CALVERT CLIFFS NUCLEAR POWER PLANT UNIT NO. 1

AMENDMENT TO FACILITY OPERATING LICENSE

Amendment No. 232
License No. DPR-53

AMENDMENT NO. 232 FACILITY OPERATING LICENSE NO. DPR-53

Figure 2.1.1-1
Unit 1 and Unit 2 Reactor Core Thermal Margin Safety Limit

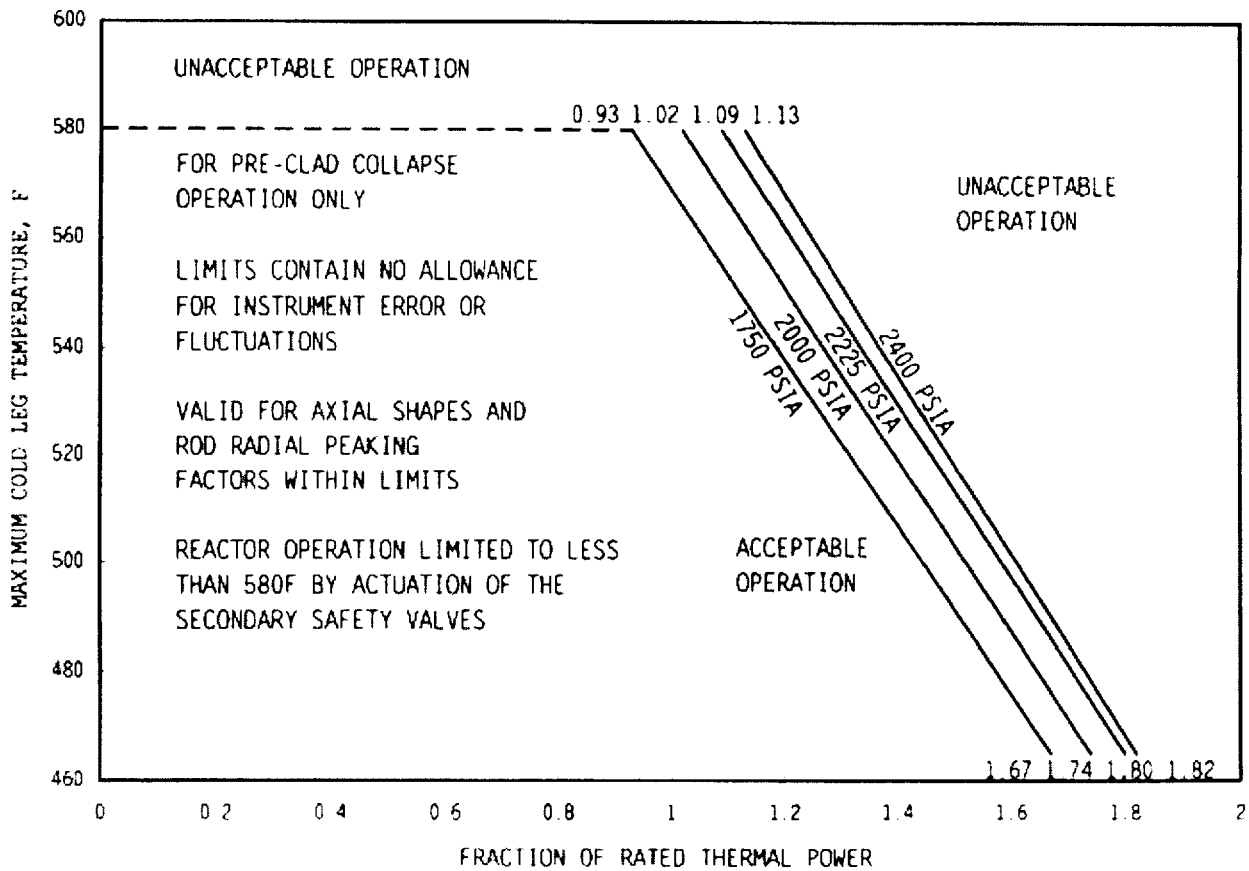
2.1.1.1 In MODES 1 and 2, the combination of THERMAL POWER, pressurizer pressure, and the highest operating loop cold leg coolant temperature shall not exceed the limits shown in Figure 2.1.1-1.
